# UNITED STATES PATENT AND TRADEMARK OFFICE

APPLICATION NO.	FILING DATE	FIRST NAMED INVENTOR	ATTORNEY DOCKET NO.	CONFIRMATION NO.
10/516,471	11/29/2004	Rabih Moughelbay	CU-5962	5737
26530	7590	12/13/2007	EXAMINER	
LADAS & PARRY LLP 224 SOUTH MICHIGAN AVENUE SUITE 1600 CHICAGO, IL 60604			MENEZES, MARCUS	
			ART UNIT	PAPER NUMBER
			3677	
			MAIL DATE	DELIVERY MODE
			12/13/2007	PAPER

<b>Office Action Summary</b>	<b>Application No.</b>	<b>Applicant(s)</b>	
	10/516,471	MOUGHELBAY ET AL.	
	<b>Examiner</b>	<b>Art Unit</b>	
	Marcus Menezes	3677

## DETAILED ACTION

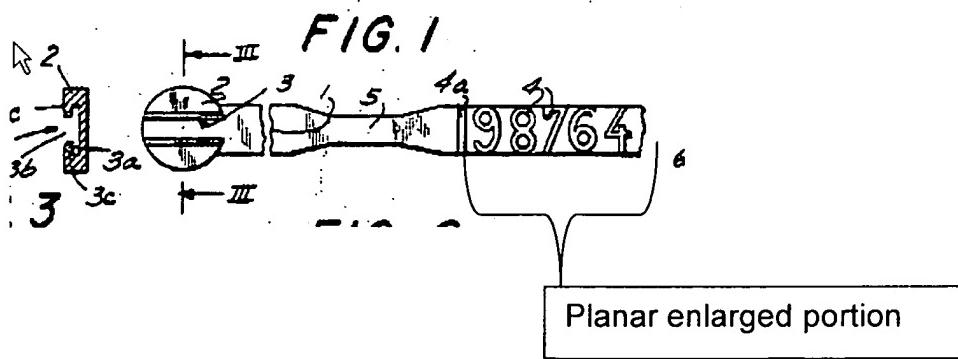
Regarding claim 70, Schumm discloses a system comprising a respective tying device, wherein each tying device comprises an elongate member (1) for releasable securement at a cable by wrapping around the cable; a planar enlarged portion arranged on the member for insertion through a hole (3a) in the member, the enlarged portion including a raised portion (4) thereon to provide that part of the enlarged portion with a thickness greater than a remainder (5) of the enlarged portion; wherein the device being configured such that the enlarged portion can be passed from one side of the member, completely through the hole, to an opposite side of the member to be secured at the opposite side; and wherein the elongate member has the same thickness as the remainder of the planar enlarged portion. (See figures 1 and 2 and below).

Regarding claim 71, Schumm discloses indicia is pre-applied on an external surface of the raised portion, wherein said indicia is the shape of said external surface.

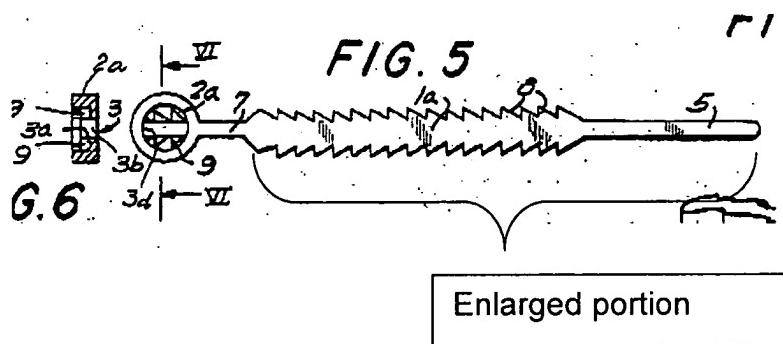
Regarding claim 80, Schumm discloses a card (fig. 16) comprising a plurality of detachable elongate members, each of the members being frangibly joined to the card for detachment therefrom, an enlarged portion being defined in at least one of the members for insertion in use through a hole (3a) located in the member, the enlarged portion being connected to at least one elongate member (7) and being inserted through a hole located in the member; wherein the enlarged portion has a transverse width greater than a corresponding transverse width of the hole. (See figure 5 below).

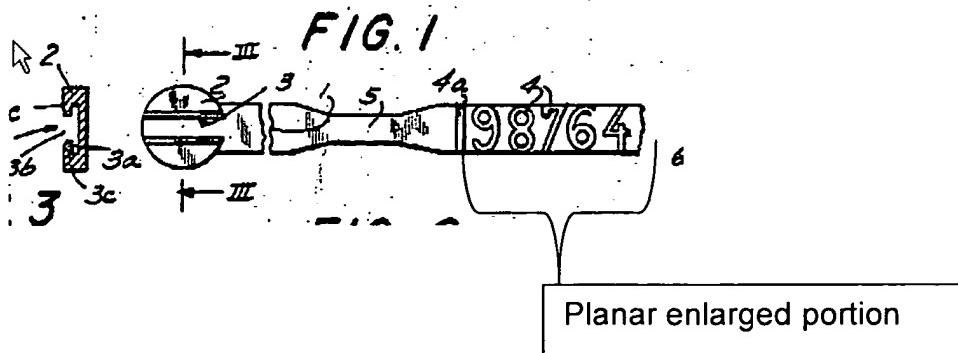
Regarding claim 85, Schumm discloses a card (fig. 16) comprising a plurality of detachable elongate members, each of the members being frangibly joined to the card for detachment therefrom, an enlarged portion being defined in at least one of the members for insertion in use through a hole (3a) located in the member, the enlarged portion being a planar enlarged portion arranged on the member for insertion through a hole located in the member, and the enlarged portion including a raised portion (4) thereon to provide that part of the enlarged portion with a thickness greater than a remainder of the enlarged portion. (see figure below)

However, Schumm states that the enlarged portion has a transverse width substantially the same as a corresponding transverse width of the hole. It should be noted that substantially is a broad term and that the friction between the side walls of the hole and the enlarged portion is necessary in order for the device to function properly; thus it would have been obvious to one having ordinary skill in the art at the time the invention was made to have included in Schumm an enlarged portion having a transverse width that is greater than the corresponding transverse width of the hole in order to impart friction between the hole side walls and the enlarged portion.
